**SUBMITTAL TO THE BOARD OF SUPERVISORS  
COUNTY OF RIVERSIDE, STATE OF CALIFORNIA**

**ITEM  
21.2  
(ID # 9716)**

**SUBJECT:** TRANSPORTATION & LAND MANAGEMENT AGENCY/PLANNING: PUBLIC HEARING on CHANGE OF ZONE NO. 7937, ORDINANCE NO.348.4909, TENTATIVE TRACT MAP NO. 37294, PLOT PLAN NO. 26249, and MITIGATED NEGATIVE DECLARATION for ENVIRONMENTAL ASSESSMENT NO. 43021 – Applicant: Newland Homes LLC – Representative: Proactive Engineering – Third Supervisorial District – Rancho California Zoning Area – Southwest Area Plan – General Plan: Community Development: Medium Density Residential (2 – 5 dwelling units per acre) – Zoning: Rural Residential (R-R) – Location: Northerly of Los Alamos Road, Southerly of De Caron Street, Easterly of Suzi Reid Way and Westerly of Briggs Road. – 12.5 acres – REQUEST: Change of Zone No. 7937 is a proposal to change the zoning classification from Rural Residential (R-R) to Planned Residential (R-4). Tentative Tract Map No. 37294 is a proposal for a Schedule “A” subdivision of 12.5 gross acre area into 48 single-family residential lots, ranging in size from 5,017 to 7,998 square feet, and also include one (1) water quality basin, and four (4) open spac

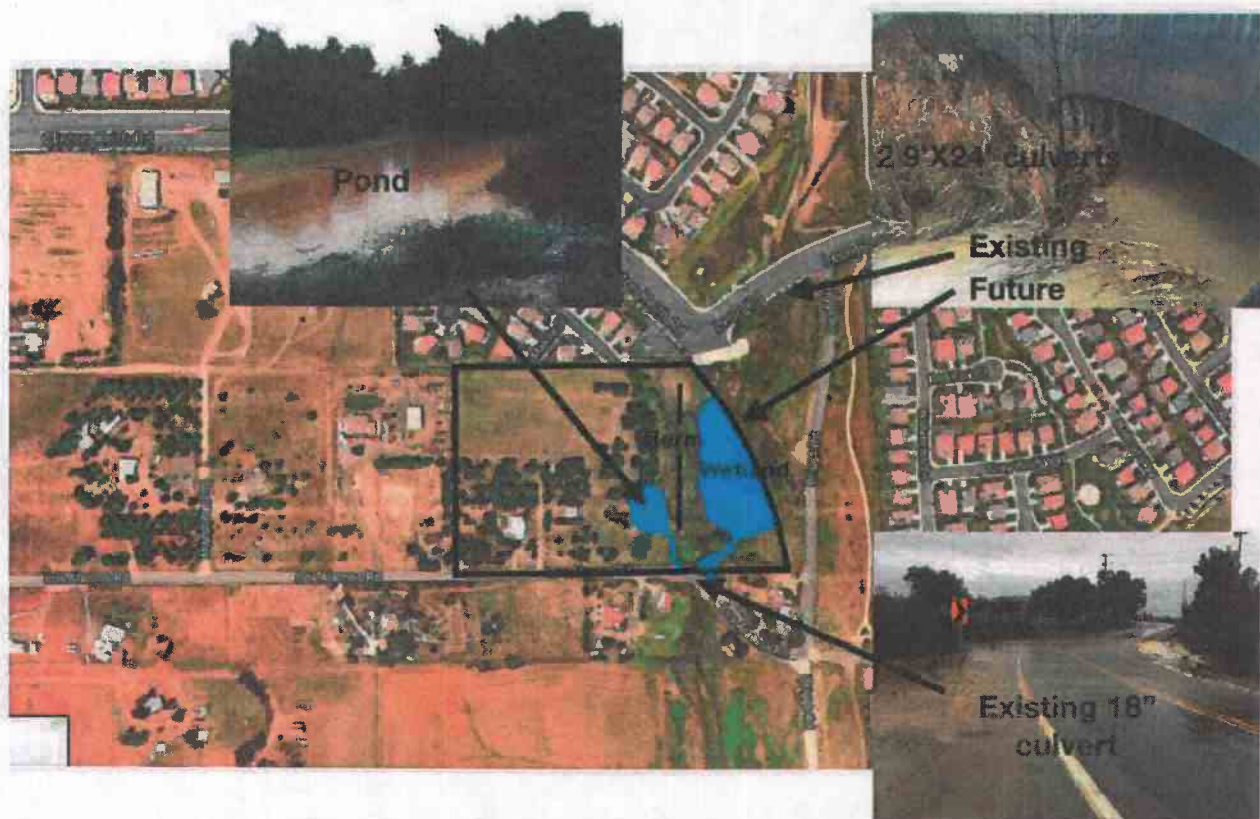
**1A: The FLOOD comments on Page 7 describe how the "stormwater runoff from".... "approximately 20 acres" flows into the project from the west. Yet EA 43021 cites a Drainage Report that fails to correctly identify the boundaries of this western watershed - instead analyzing drainage from only a portion of the true western watershed, and OMITTING drainage from parts of 4 multi-acre parcels south of Los Alamos Road (southwest of the project site) that contribute to flooding on properties north of Los Alamos Road. This material error is grounds for rejecting the Mitigated Negative Declaration.**

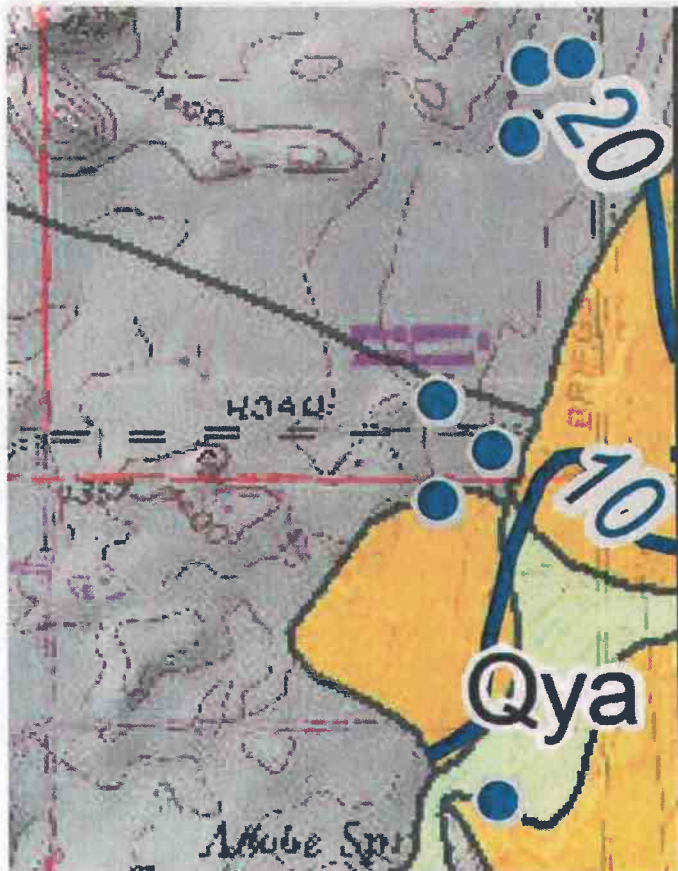
**5. On page 40 of EA 43021, in checklist 25e) Applicants certify that the proposed project will have a less than significant impact by placing housing “within a ... flood hazard delineation map”.**

Consideration of the RCFCWCD - Public Flood Hazard Determination map for the project shows that approximately 20% of the project’s proposed housing units, parts of proposed Streets A and C and the proposed new detention basin are all placed in a flood hazard area:

The Initial Study *fails to describe the flood hazard and what structures are proposed to be placed in the flood hazard area* shown on the RCFCWCD - Public Flood Hazard Determination map. The Initial Study should have clearly addressed this material issue, hence the Applicant's determination under 25d on Page 40 is defective. Therefore, the application for Mitigated Negative Declaration should be rejected.
